Item Change – Air Top 2000 Power/Switch Harness

01-20-2002

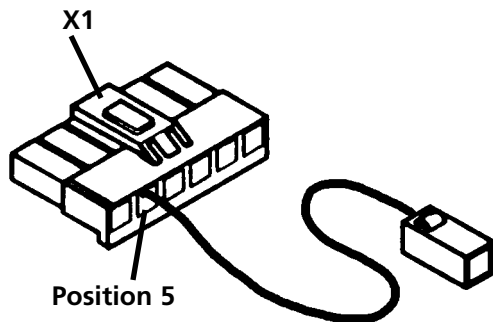
Starting the last quarter of year 2001, all Air Top 2000 Power/Switch harnesses were redesigned to omit the diagnostic link. A new Item is now available to take the place of the diagnostic link which was previously part of the harness.

For Webasto service facilities and end-users utilizing the PC diagnostic capabilities of the Air Top 2000 heater, the NEW adapter (pigtail) is required to allow communication between the heater and the diagnostic kit where the new power/switch harness is in use. The new adapter can be ordered under part number 5000007A.

The new adapter (pigtail) is inserted into position 5 of the X1 connector that plugs into the control circuit board. Once installed, the diagnostic kit can be connected in the usual manner as before, using the appropriate diagnostic adapter (P/N 1319943A) included in the PC Diagnostic kit.

New Adapter (Pigtail) P/N 5000007A

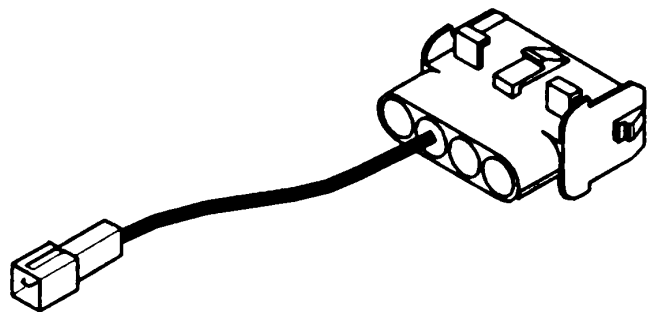
The above items illustrated can be ordered separately or together as a kit under part number 5000009A.
